**50-KILOBIT WIDEBAND LOOP
1 THROUGH 50 KHZ
WLR-5 REPEATER
INSTALLATION AND CONNECTION**

1.001 This addendum supplements Section 314-643-200, Issue 3. Attach this pink sheet in front of Page 1.

Fig. 6—Tip and Ring Continuity Strapping

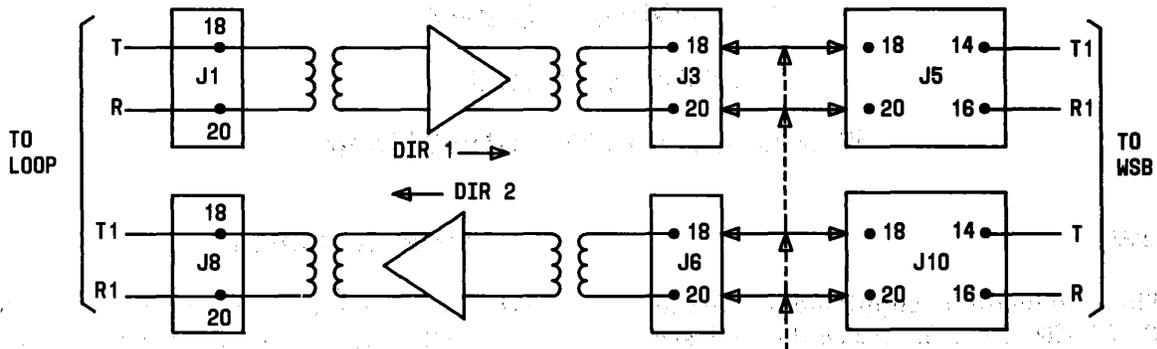
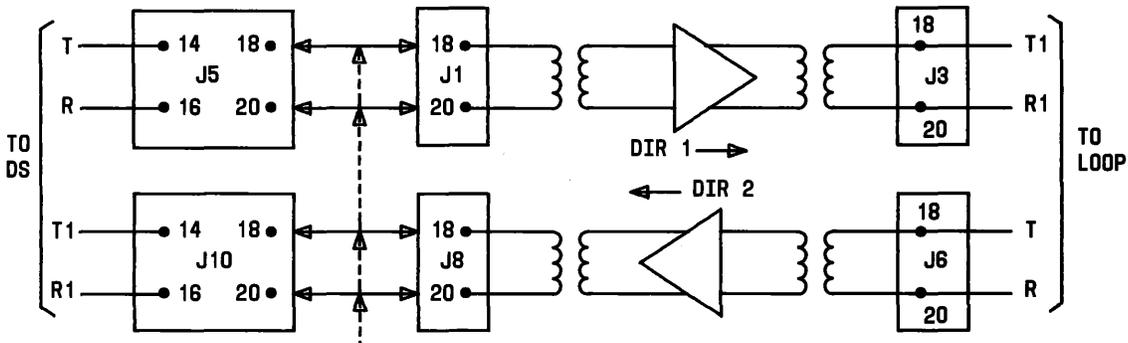
2.001 On Page 3, paragraph 3.03, add the following: The installer must strap certain connector pins located at the rear of a terminal and customer repeater. See Fig. 6.

NOTE: INTERMEDIATE REPEATER DOES NOT REQUIRE TIP AND RING CONTINUITY STRAPPING BY INSTALLER.

STRAPS TO BE MADE BY INSTALLER

STRAPS TO BE MADE BY INSTALLER
